## TECHNICAL MEMORANDUM

**RE:** Portland Water Bureau Water Filtration Project  
Initial Cursory Review  
True North Project: 23-0108

## PWB Treatment Plant - T3-2022-16220 Comments

Figure 2 - Well Locations

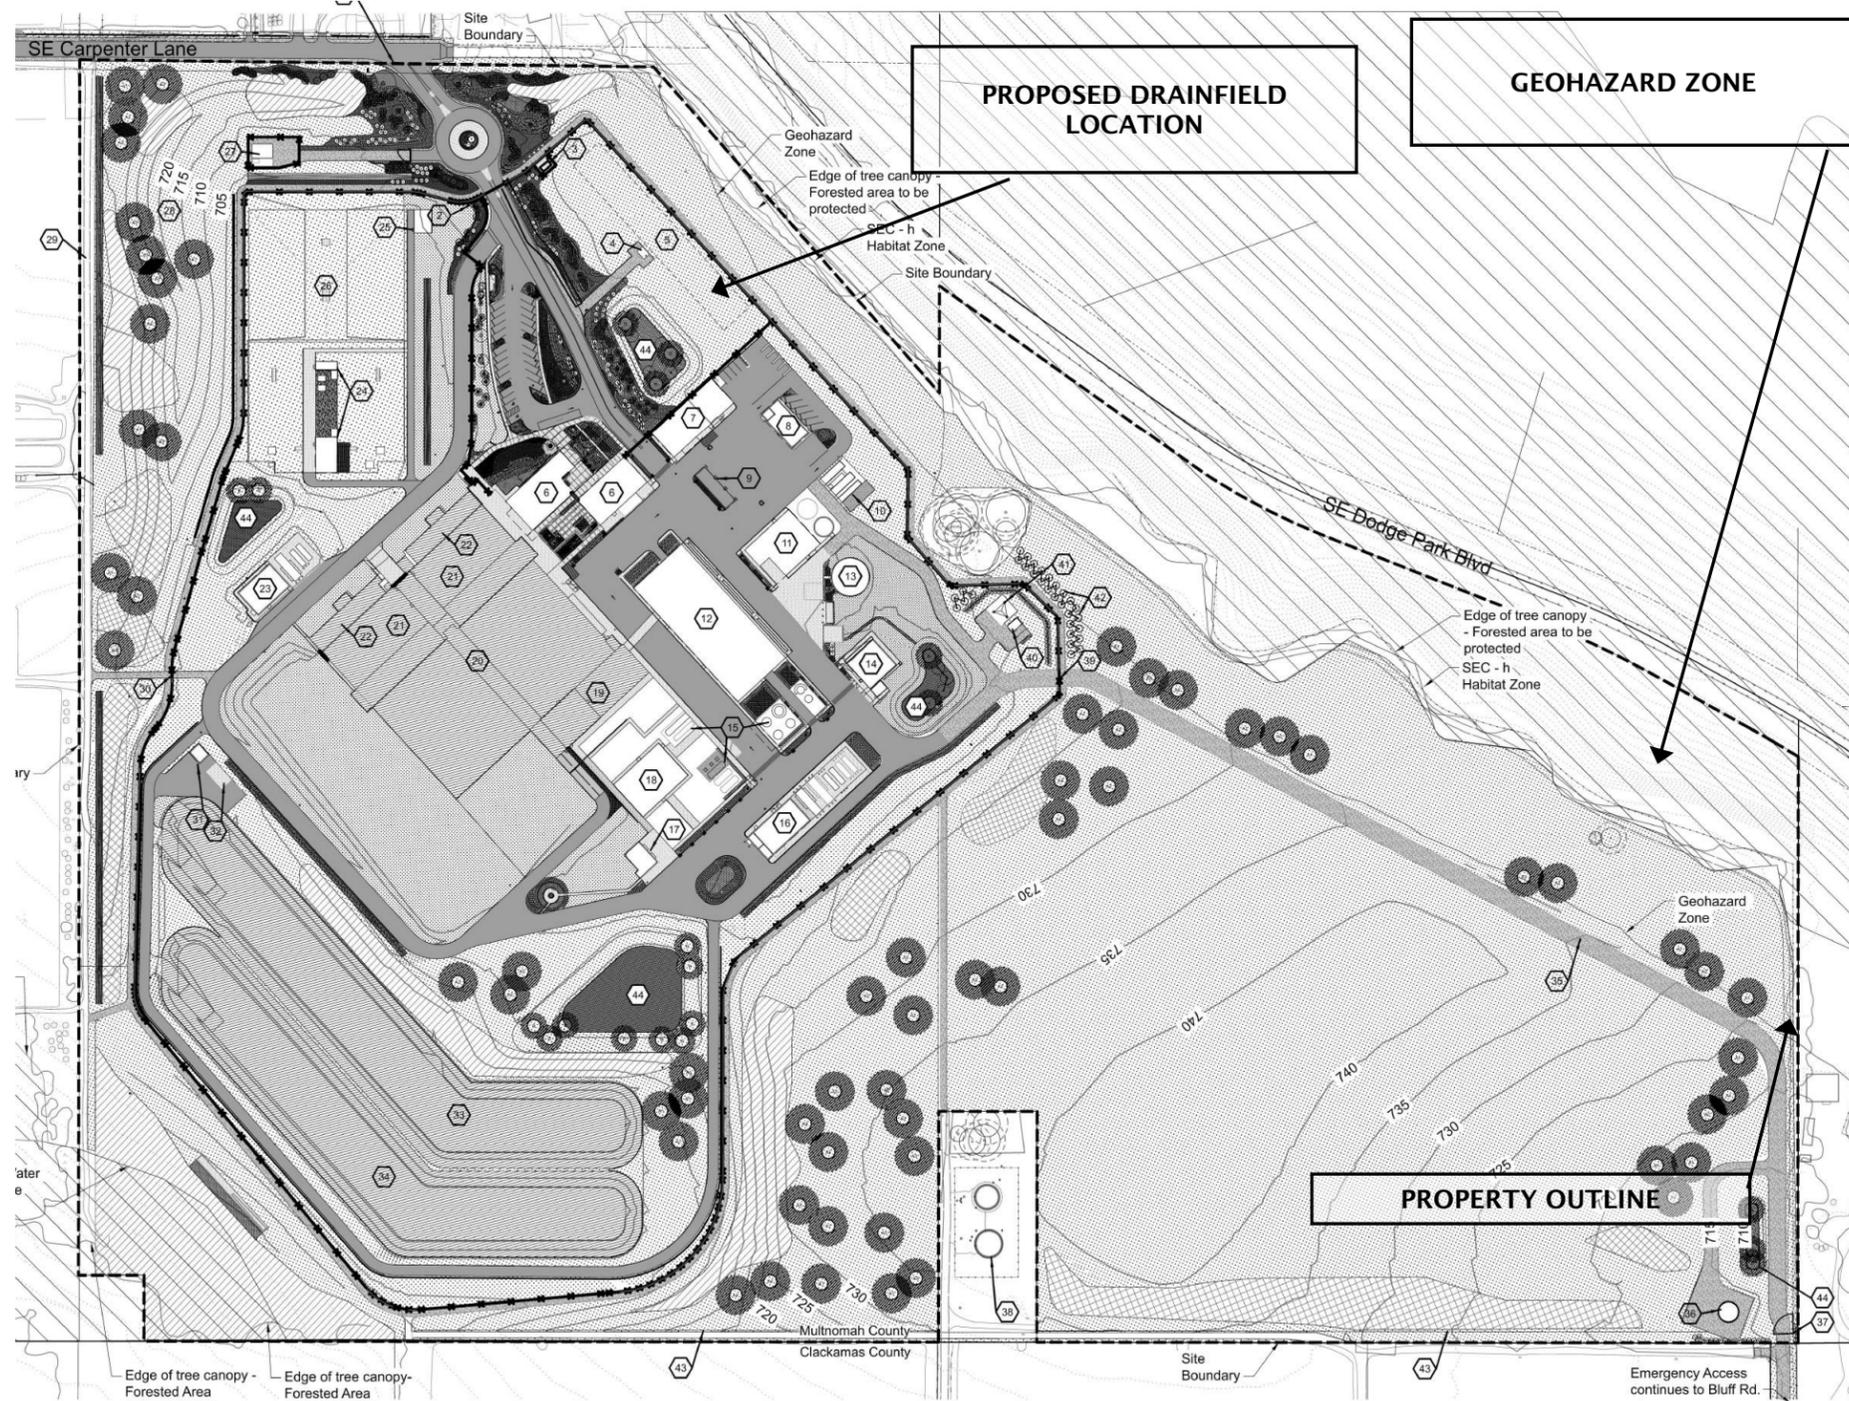
Water Wells – True North was able to locate at least 2 monitoring wells, used for observing groundwater levels, flow condition, etc., on the Property during our site walk on June 21, 2023. Based on OWRD records, it appears a minimum of 170 water/monitoring wells are located within a mile radius of the Property from SE Lusted Road to SE Proctor Road (see Figure 2 attached). Details on water wells may have been addressed in documents not available for our review at this time. However, we recommend further study, including mapping, of existing irrigation and domestic wells to determine if water/monitoring wells are located within areas of proposed construction of the facility and/or pipelines or could be negatively impacted by future construction/operations on the Property. If there are wells situated within construction areas, they will need to be abandoned/decommissioned or replaced by a licensed well driller per Chapter 690 of State of Oregon Water Resource guidelines. If there are domestic or irrigation wells which could be impacted, we recommend further study to preserve existing water production, quality, and rights. Also see comments in the Tunneling section within this memorandum.

Tunneling – Large diameter pipelines will be located at depth below overlay zones mapped adjacent to the Property. There is the potential existing irrigation/domestic wells, which have an average depth of 200 to 300 feet below ground surface (bgs), may be impacted by tunneling methods. As detailed on Figure 2, a cluster of irrigation/domestic wells are mapped by OWRD as being within the proposed tunneling area located below SE Dodge Park. Groundwater levels are anticipated to be near 150-feet bgs. Tunneling activity in water-bearing ground may result in unwanted groundwater inflow into the excavated area, causing some groundwater drawdown within nearby wells. Details on tunneling may have been addressed in documents not available for our review at this time. However, we recommend mapping and detailed research of existing irrigation and domestic wells to determine if they are located within the proposed tunneling area or could be impacted by future construction and/or operations on the Property. In addition, we recommend groundwater control systems and prevention of groundwater intrusion be factored into the design of proposed tunneling.

<p><b>TRUE NORTH</b> ◆ GEOTECHNICAL ◆</p>	<p>Cottrell CPO Portland Water Bureau Water Filtration Facility Gresham, OR</p>	<p>Project # 23-0108-1</p>
<p>219 West 4<sup>th</sup> St Vancouver, WA 98660 360-984-6584</p>	<p>June 2023</p>	<p>Figure 1 - Proposed Development</p>

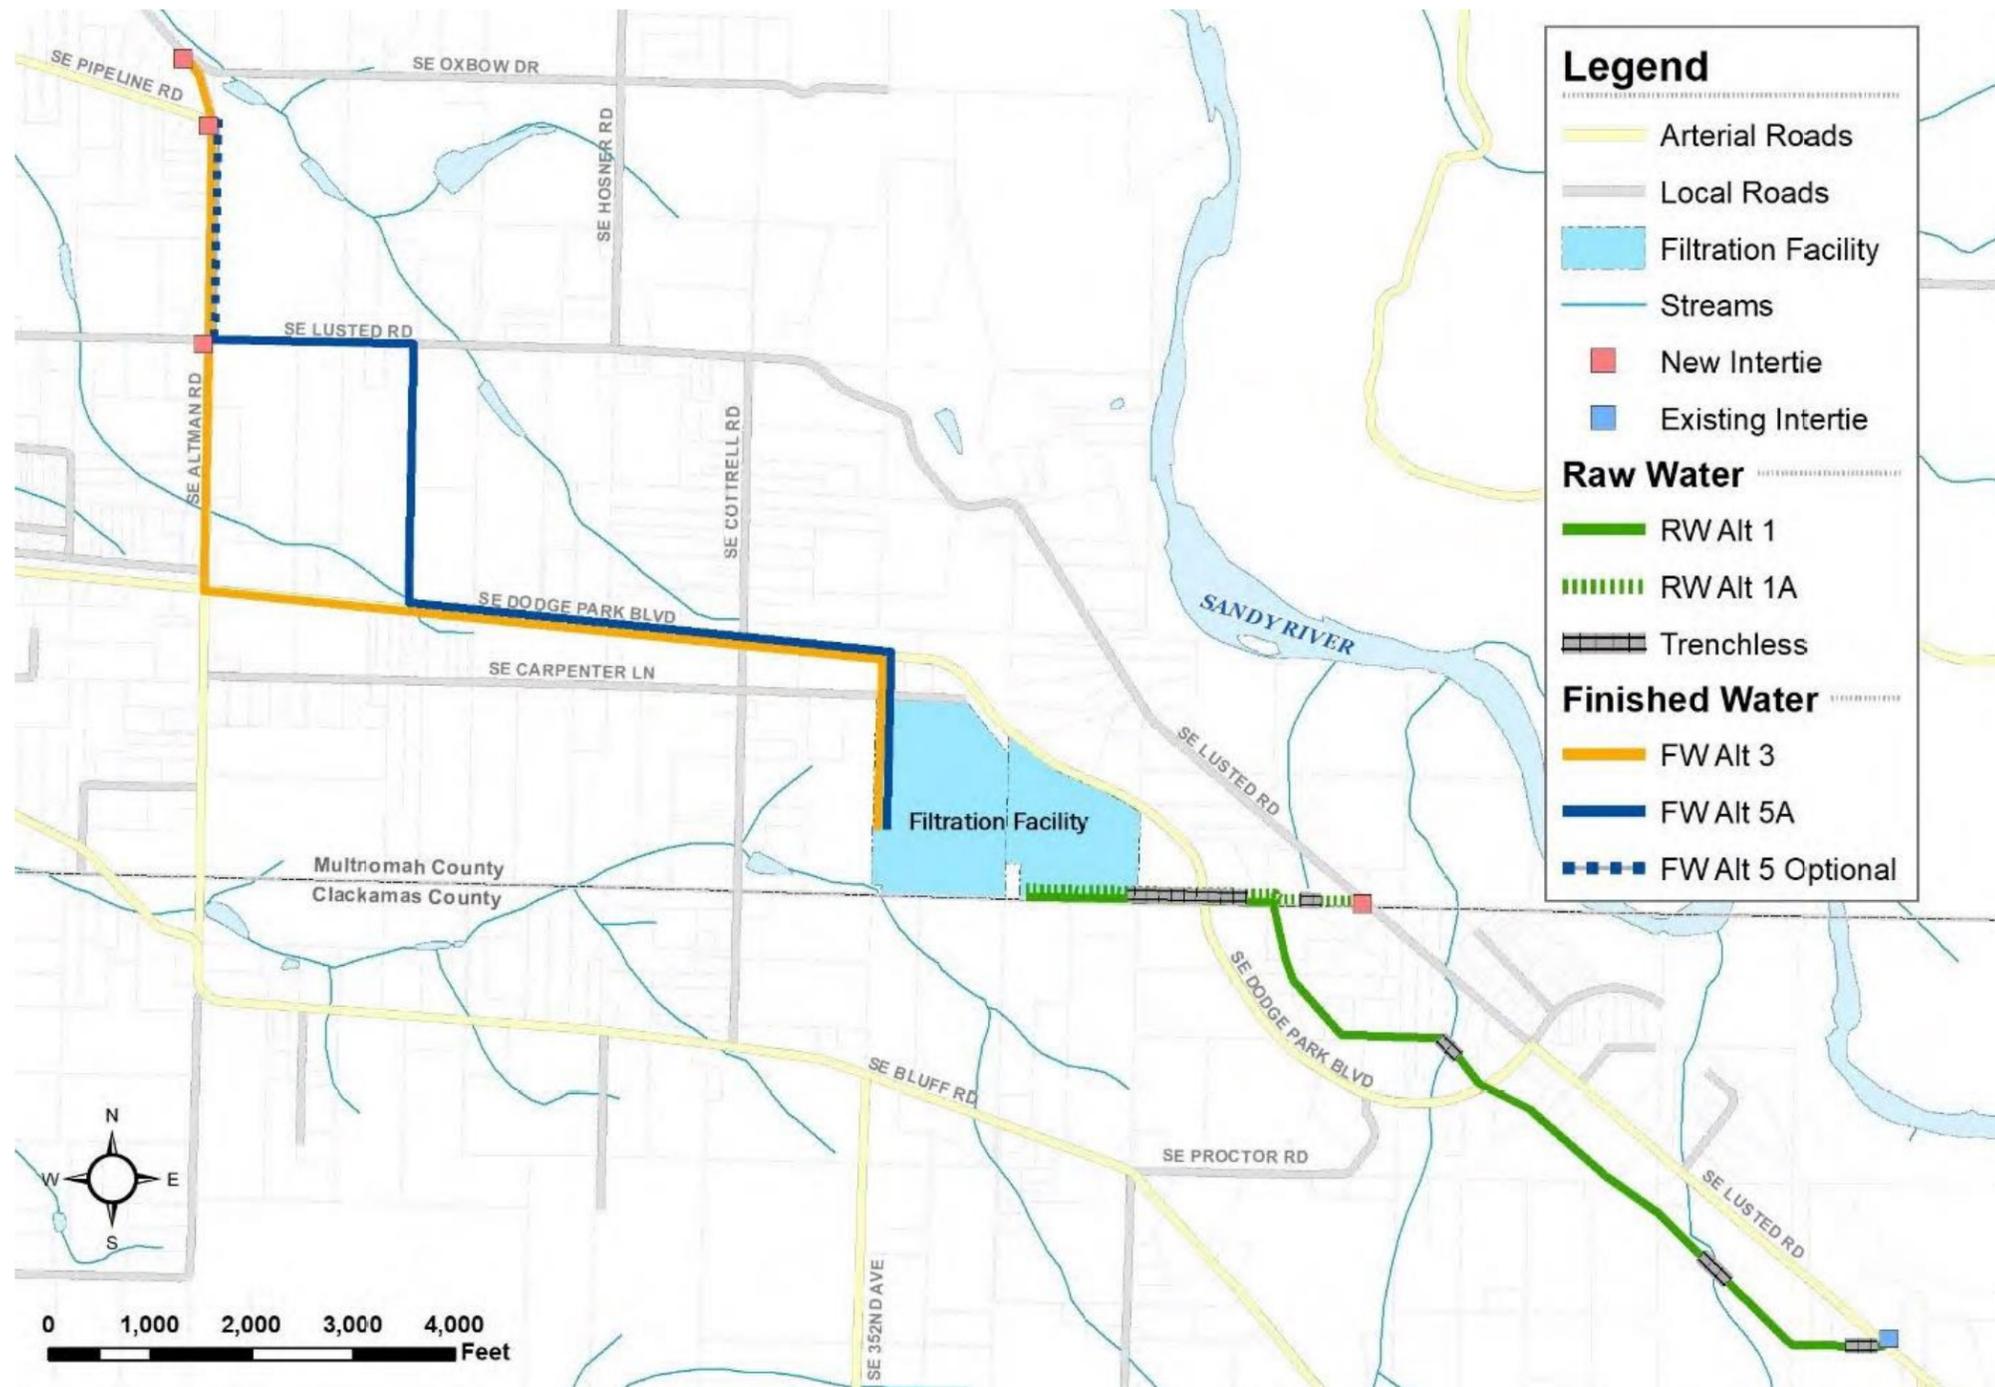
Septic – On site septic systems are proposed for the Property. Details on septic design may have been addressed in documents not available for our review at this time. However, with steep slopes and associated Geologic Hazard Overlay (GHO) zones situated approximately 60 feet northeast of a proposed drain field on the Property, we recommend further evaluation be conducted to confirm drainage will not discharge into the GHO.

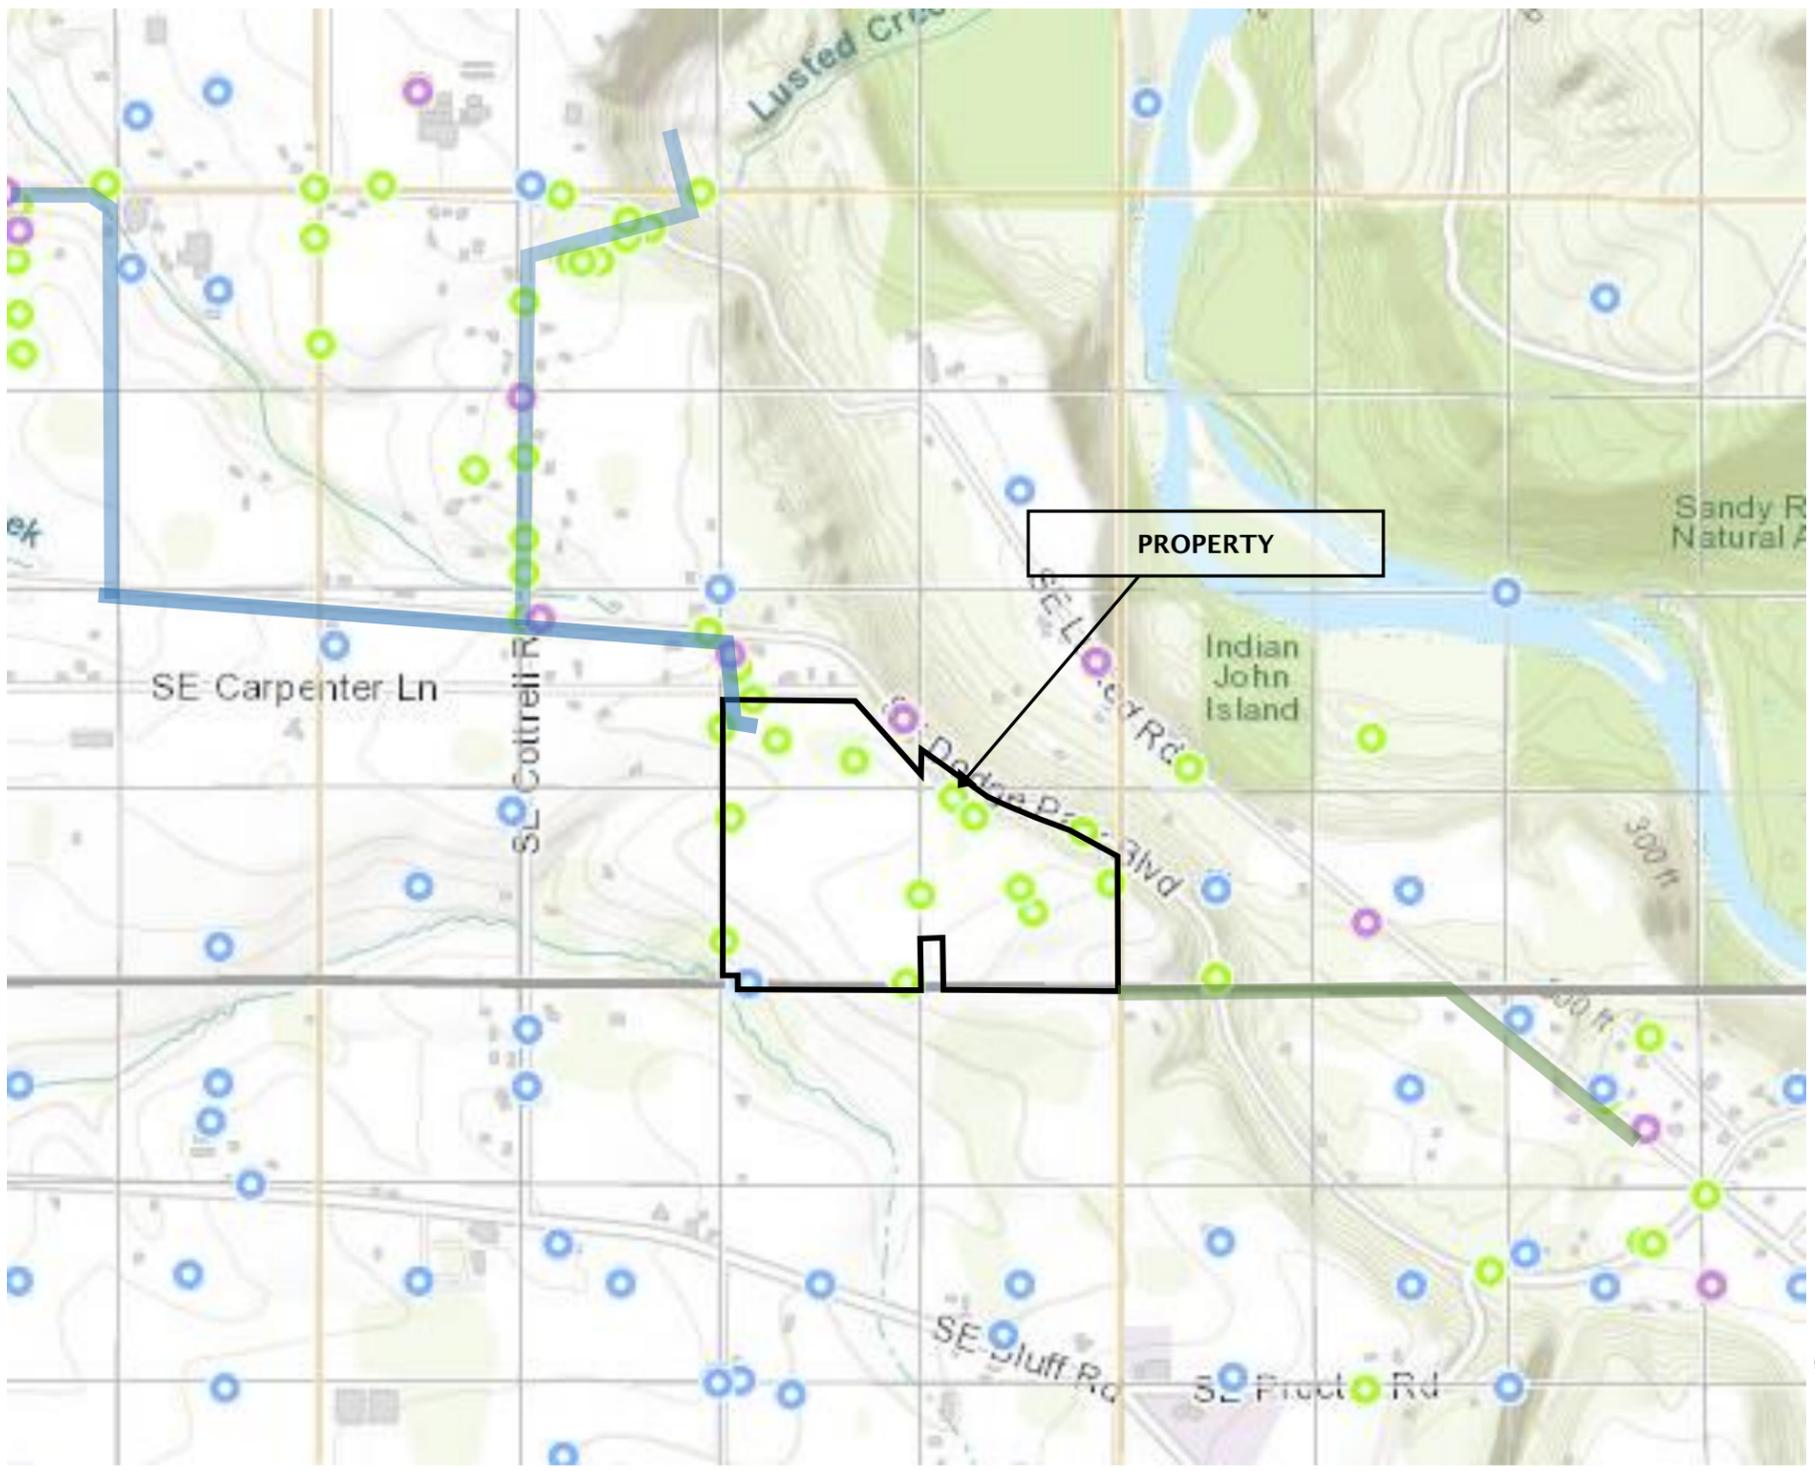
In addition, 2-miles of new pipelines will be constructed to and from the filtration facility (see Figure 1B attached). Pipelines will consist of the following:

- Raw Water (i.e., unfiltered) pipelines along SE Dodge Park Boulevard, SE Lusted Road with trenchless crossings (tunneling) under SE Dodge Park and SE Proctor Road.
- Finished/Treated Water (i.e., filtered/treated) pipelines along SE Dodge Park Boulevard, SE Lusted Road and SE Altman Road.
